HISTORIC PRESERVATION COMMISSION MEETING

Case COA26-10: Request for rehabilitation of the auto house at 627 Ripley Street. The Louis P. and Clara L. (Krause) Best House is a contributing structure in the Hamburg Local Landmark Historic District. David Cordes and Bryan Pattschull, petitioner. [Ward 3]

CERTIFICATE OF APPROPRIATENESS

18-82-010 - Best Residence and Auto House - Post Part 3 Amend 1 - Approved

Number 7	Feature: East and Northeast Wall	Date of Feature: 1910
----------	----------------------------------	-----------------------

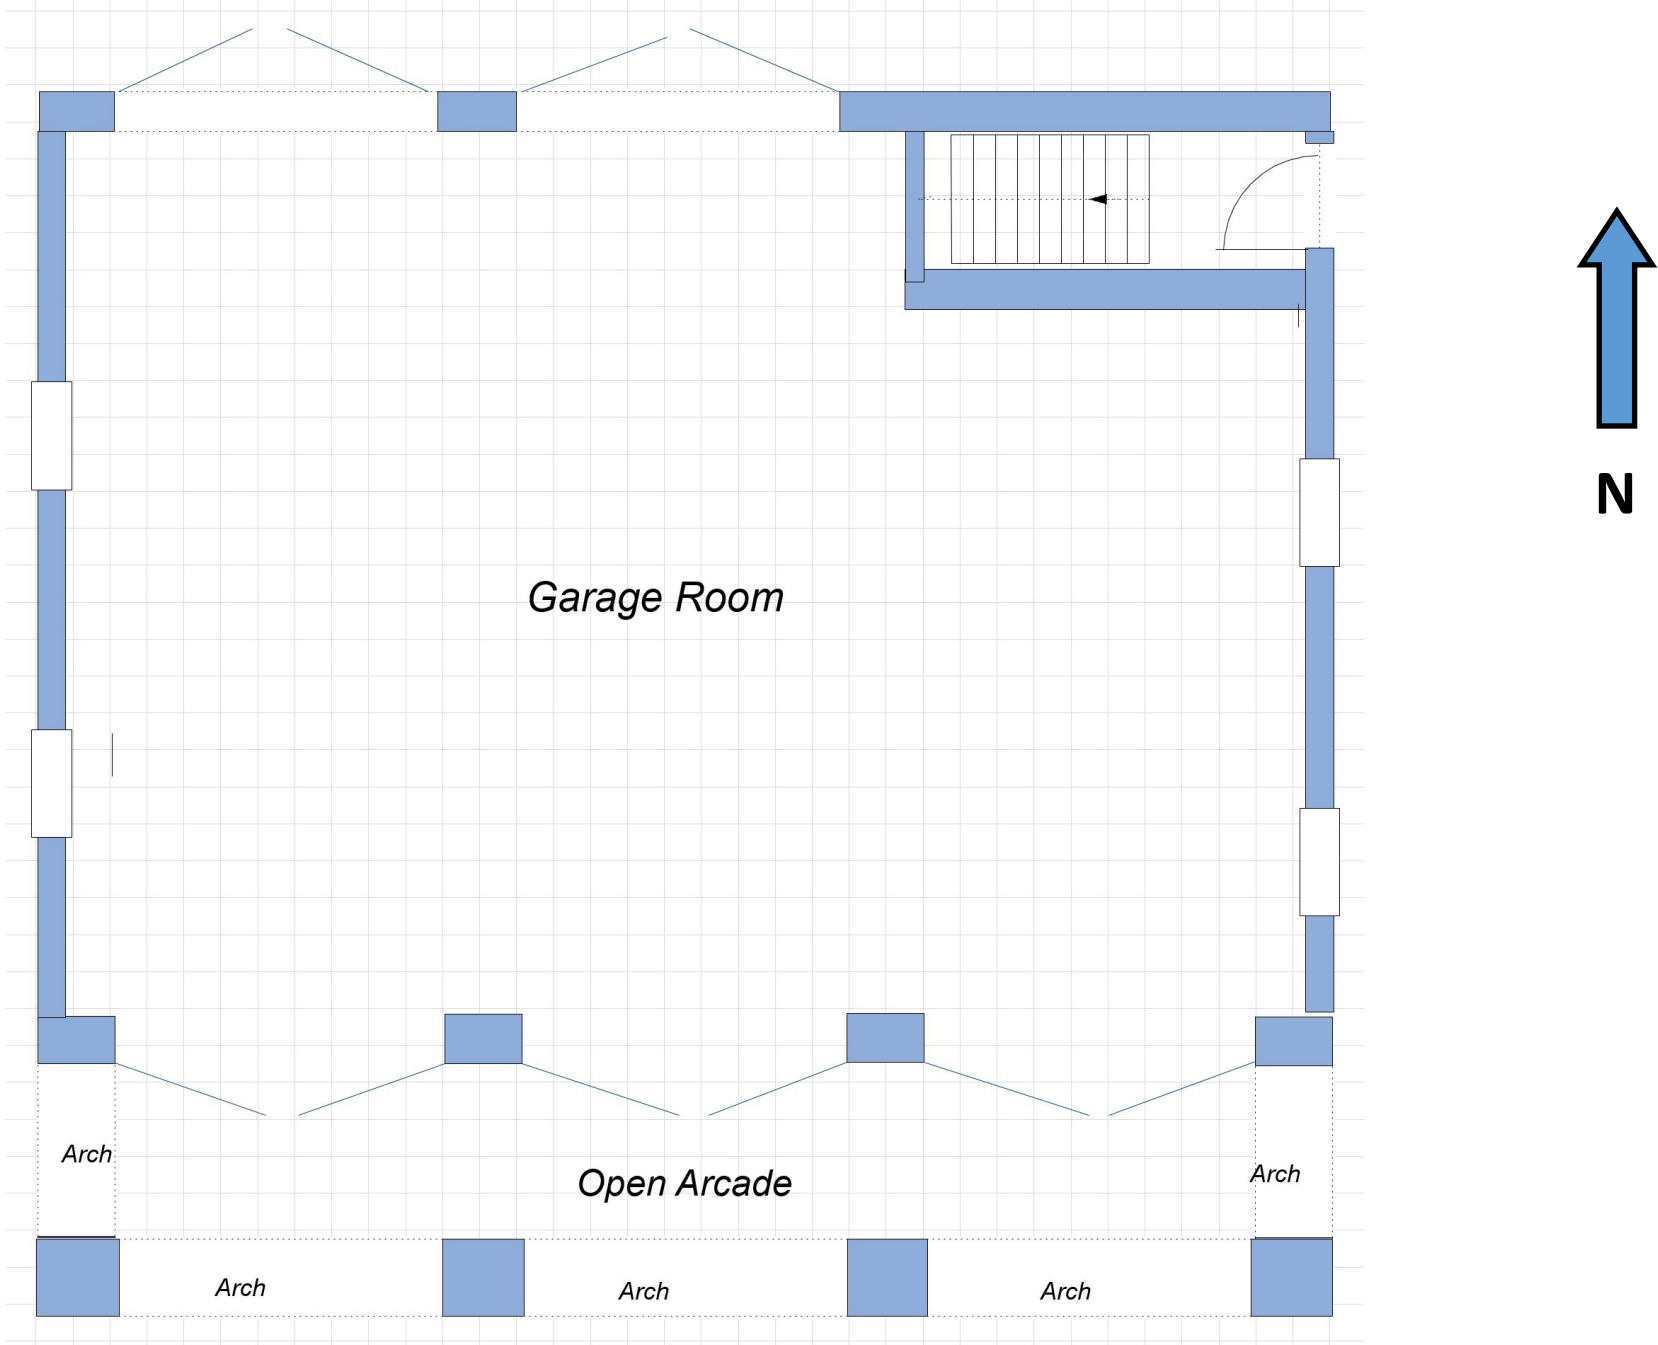
The east wall has been subjected to forces caused by earth movement beginning in 1920. Substantial work was completed in 1950 to stabilize the foundation and structure. Parts of this work began to fail over time. Additional stabilization work, which was quite substantial was completed in 2012. This work has caused any movement in the structure and its elements to cease. However, the effects of previous movement over time have left the first story level of the stucco covered masonry wall distorted with the lower part of the wall flared out to a noticeable degree. No new movement has occurred for about 13 years.

The upper wall will be supported by needle beams and temporary posts as necessary. Portions of the wall will be dismantled and reconstructed, a small portion at a time, restoring proper alignment of the overall wall. Original window openings will be maintained in exact location and exact size. This is a repair and not an alteration. When completed, the wall will look the same as it does now except it will be straight and plumb. Exterior stucco and paint will be matched, etc. Interior white and brown finish brick will be reused.

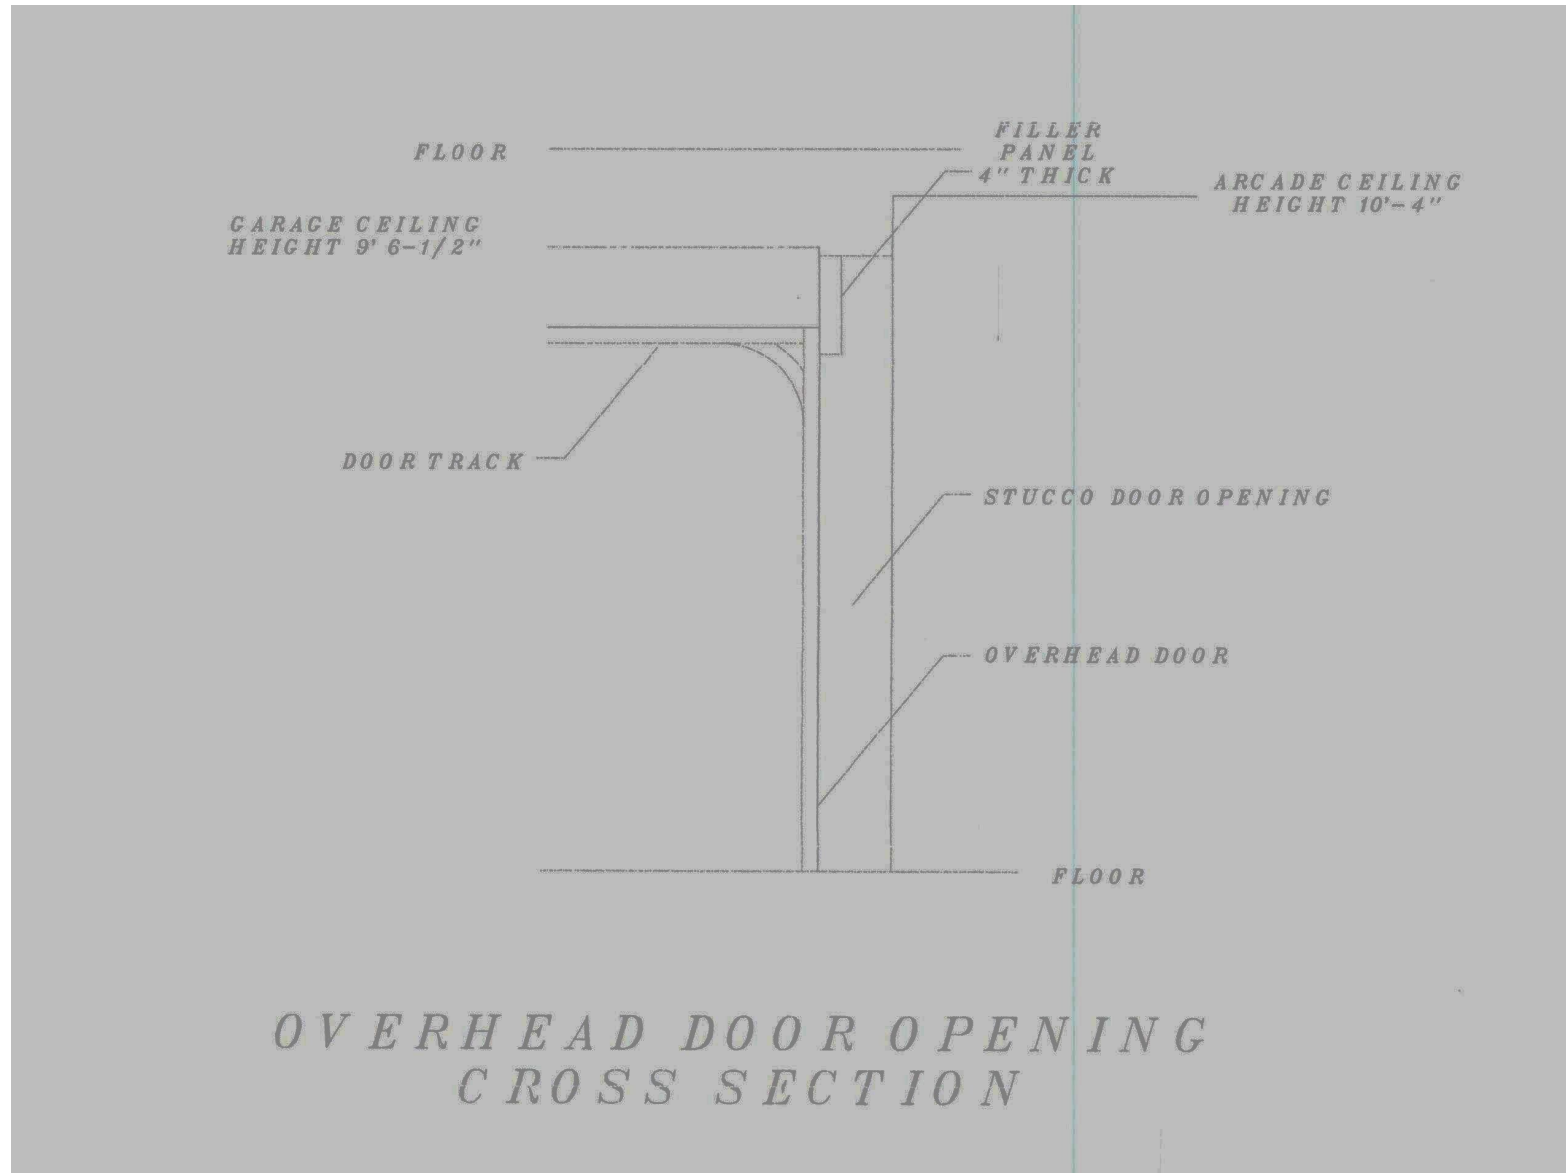
Proposed replacement overhead garage doors to be installed in the original location of the original outswinging doors. Wood construction, true divided lite, tongue and groove overlay plus crossbuck and frame overlay on top of t&g. In-fill panel above 8 ft door. In-fill to be 4" thick set to the back of 14" thick smooth stuccoed masonry opening. Image April 2026.

Best, Louis P & Clara L K, Auto House.
Plan drawing 1, Page 39.

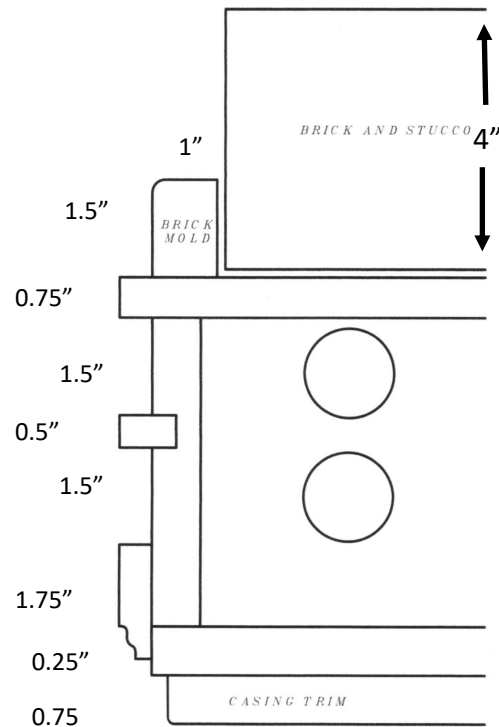
Single glass, clear, with a VLT of 90% or more.

Full window screens to be provided. No storm windows. Window screens constructed of wood frames and metal, black colored, low sheen screen wire.

WEST WINDOWS
TO FIT BRICK
OPENINGS
35"W X 100"H
DIMENSIONS TO
BE VERIFIED

EAST WINDOWS
TO FIT BRICK
OPENINGS
35"W X 71"H
DIMENSIONS TO
BE VERIFIED
